PLANNING COMMISSION  
DATE: 4/27/15  
AGENDA ITEM: 5B – BUSINESS ITEM  
CASE # 2015-16

ITEM: Village Preserve Final Plat

SUBMITTED BY: Nick Johnson, City Planner

Re: Village Preserve – Parcel B  
Final Plat/Construction Plan Review

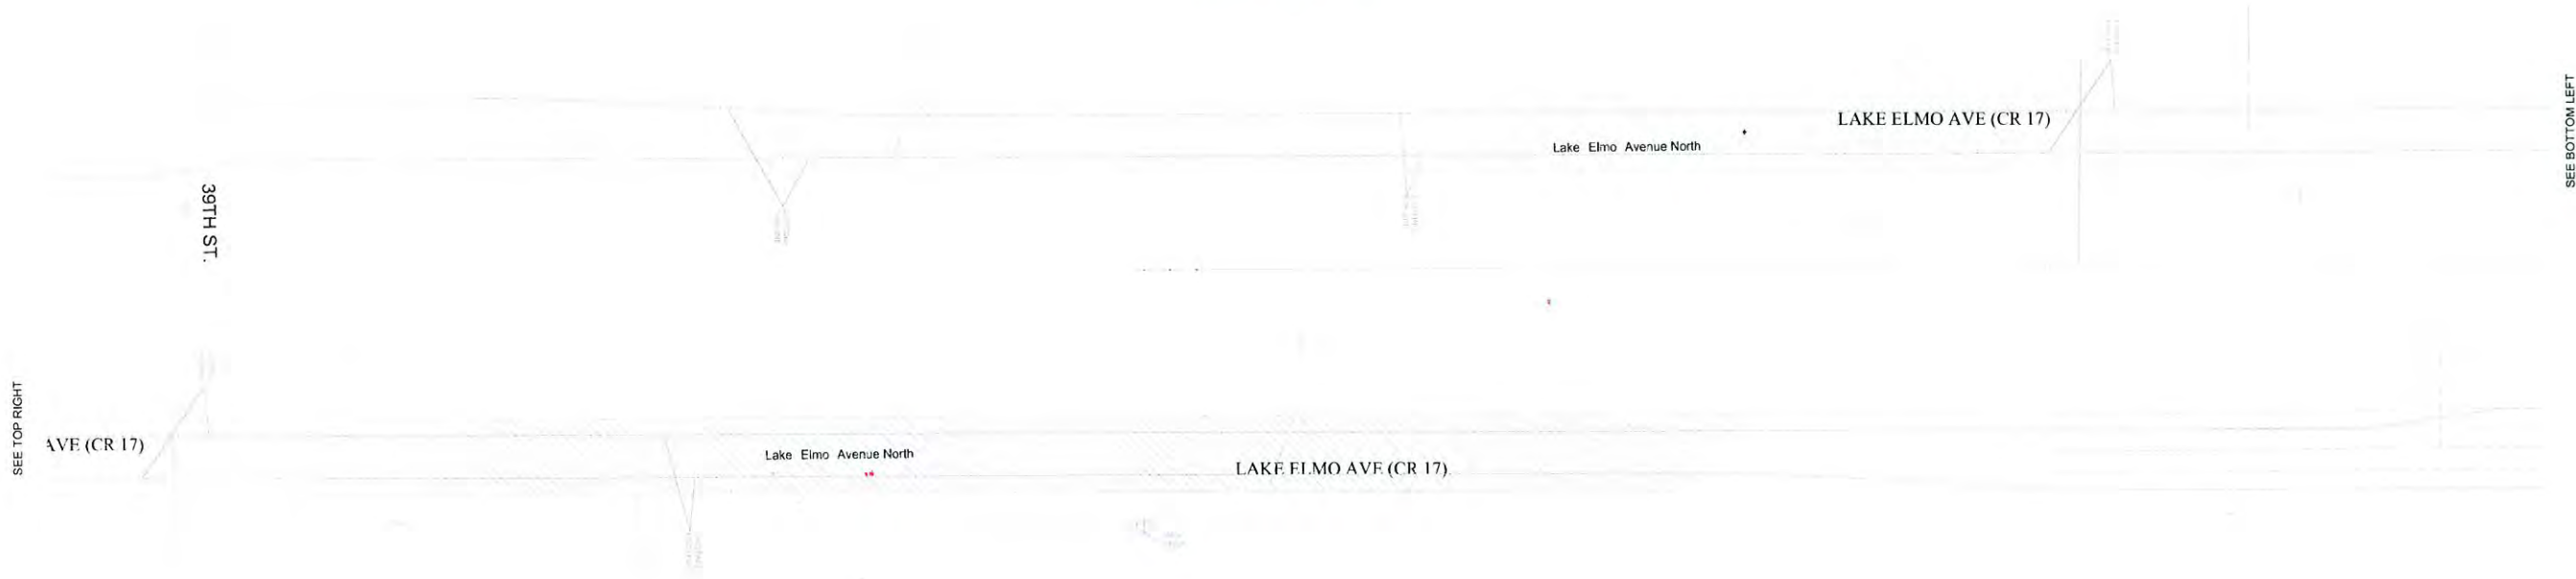
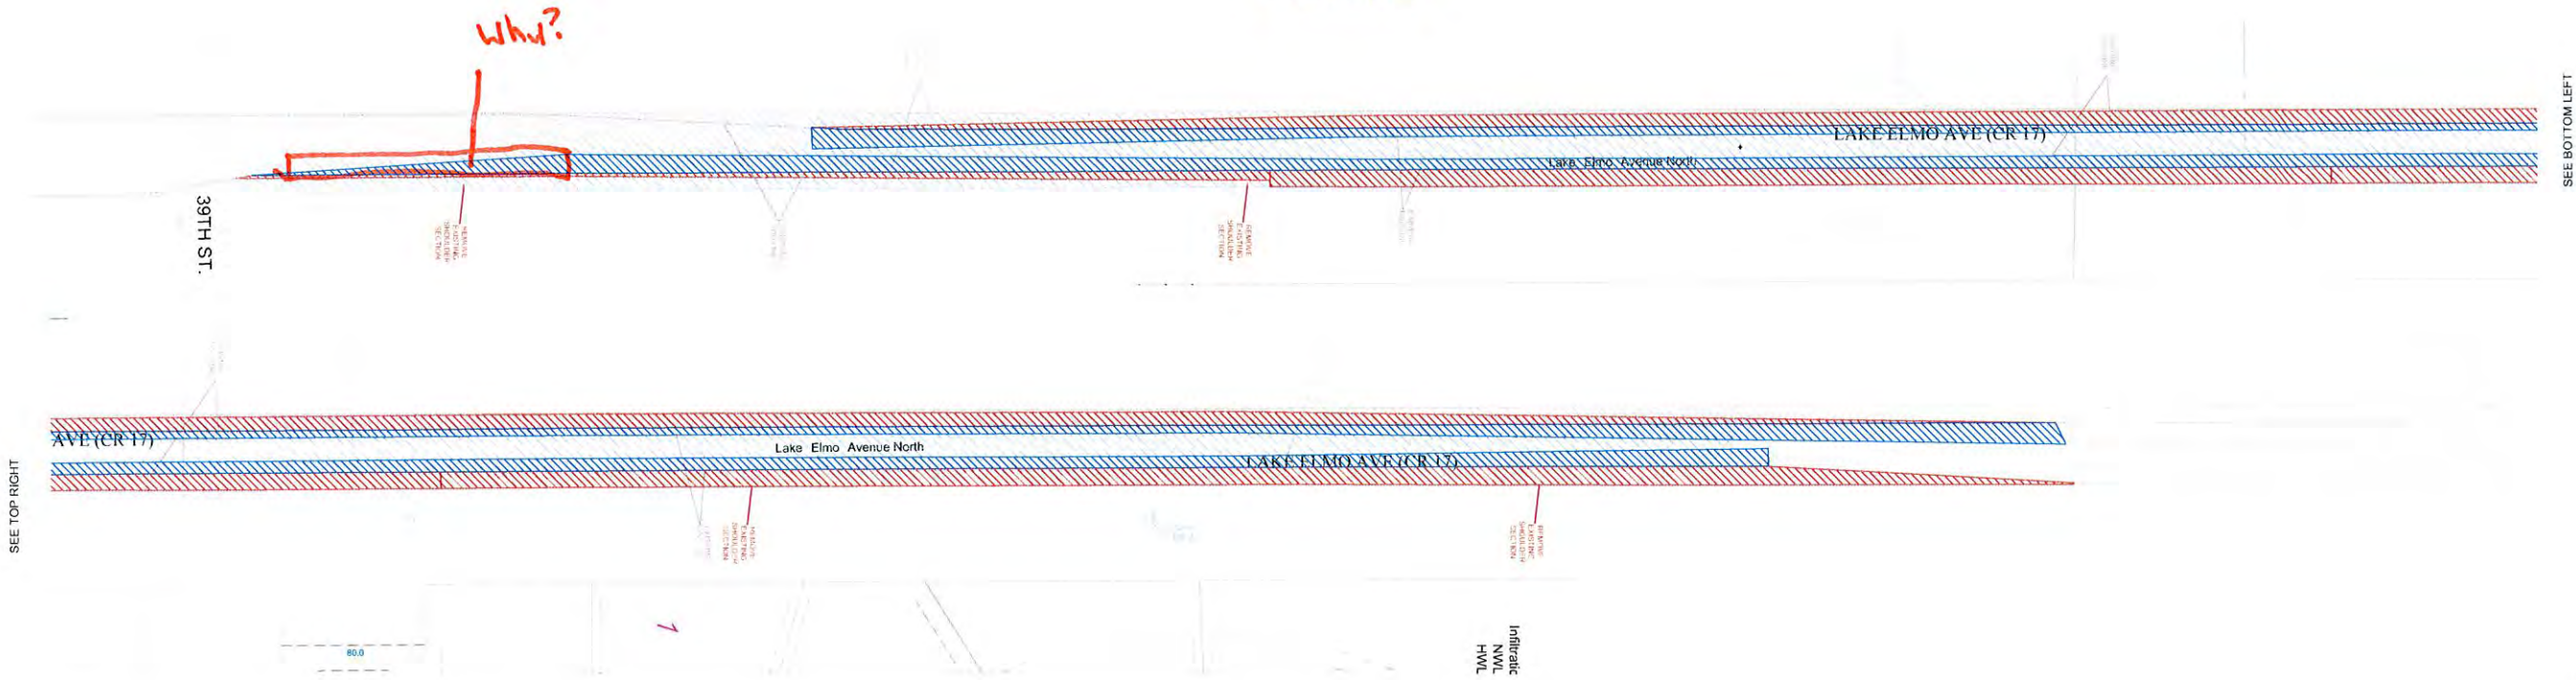
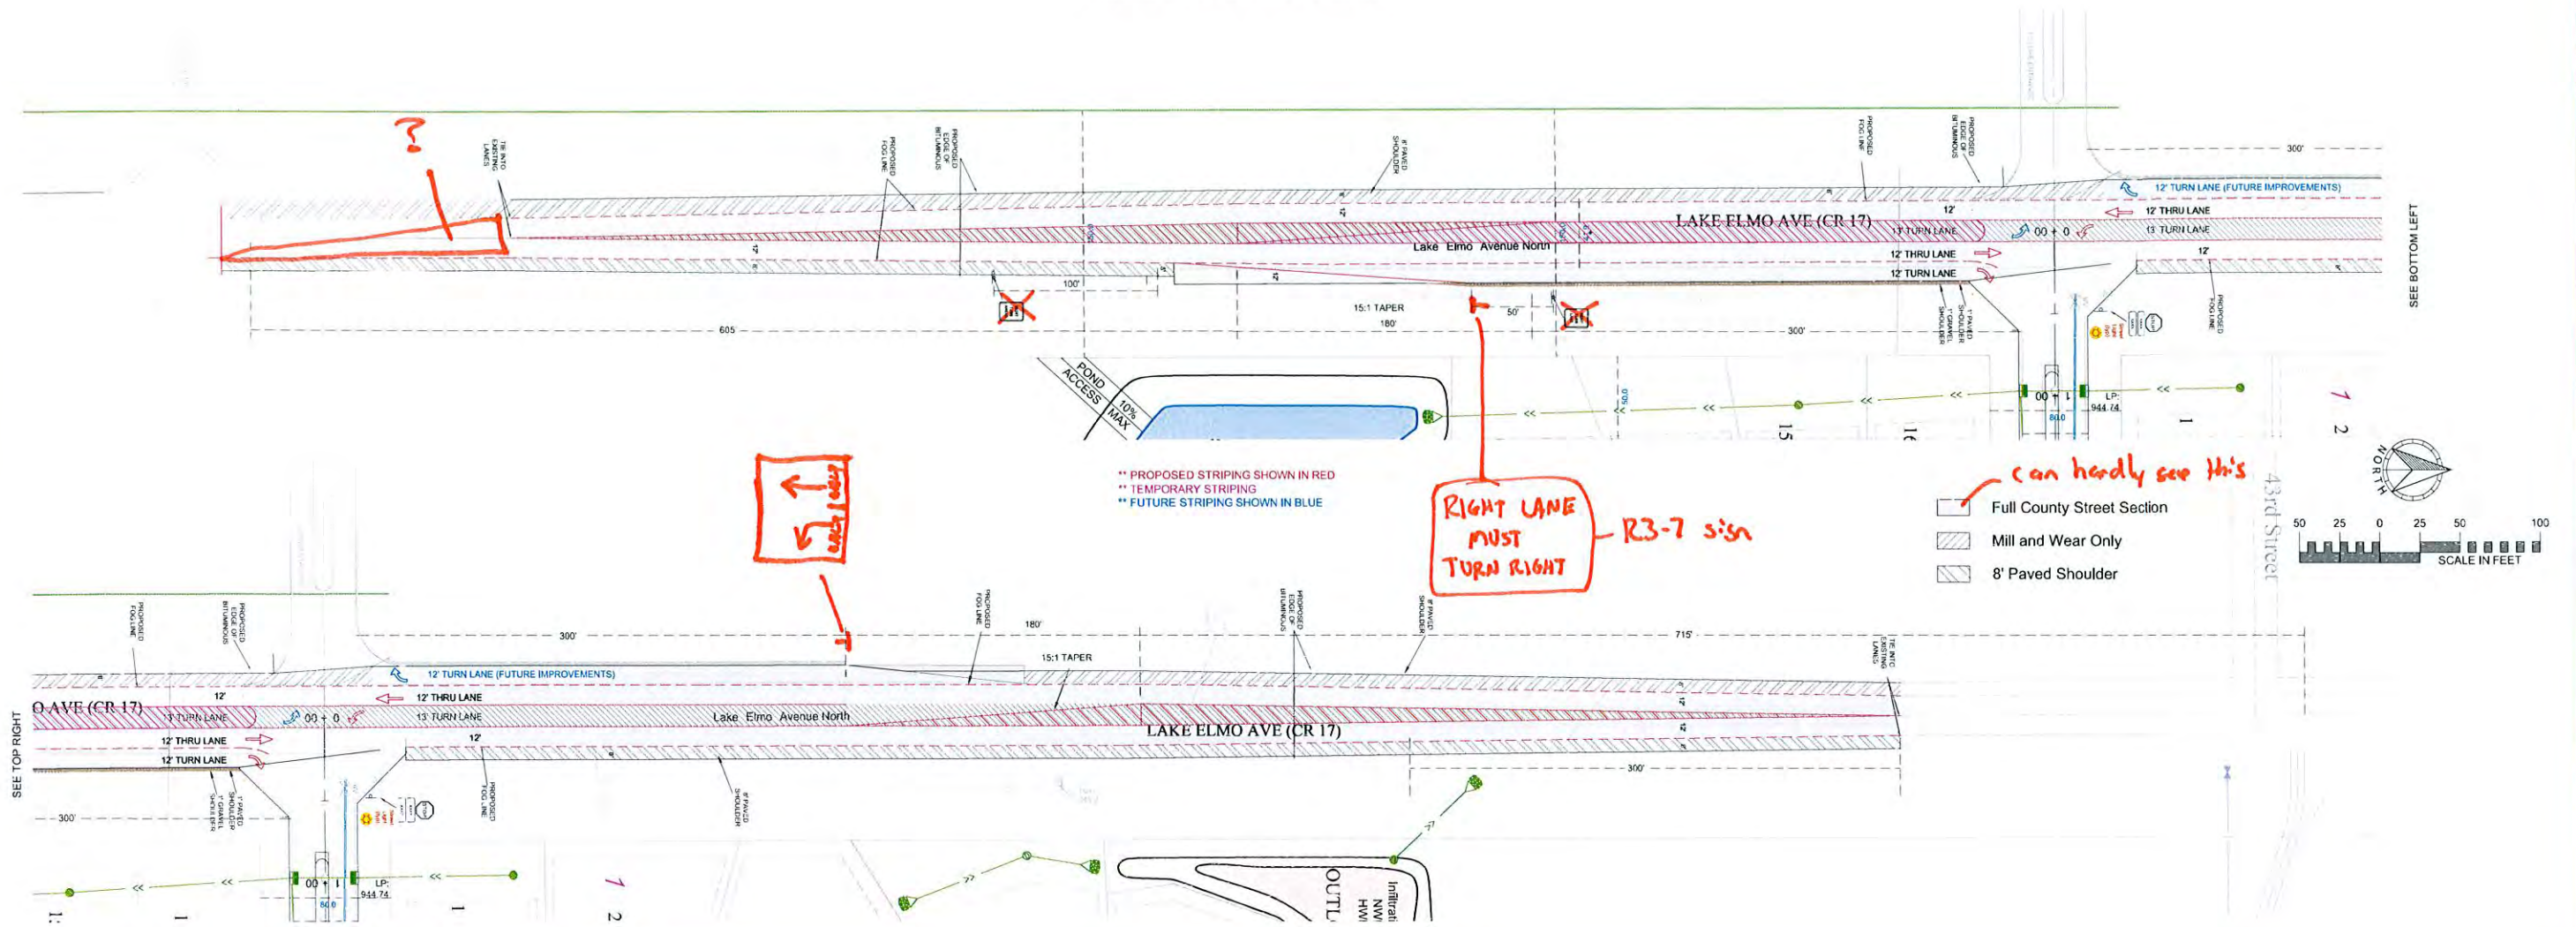
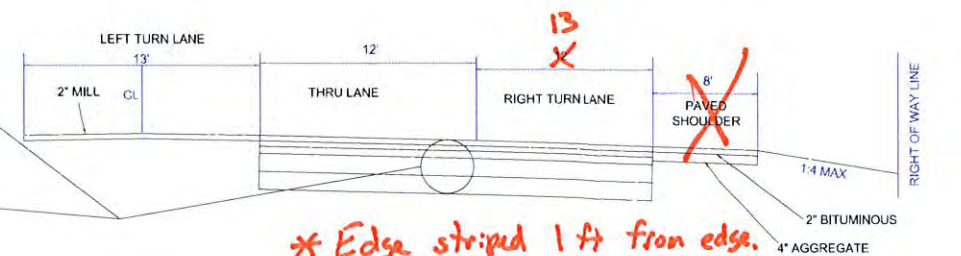
Carol

Carol Hanson

Washington County Public Works
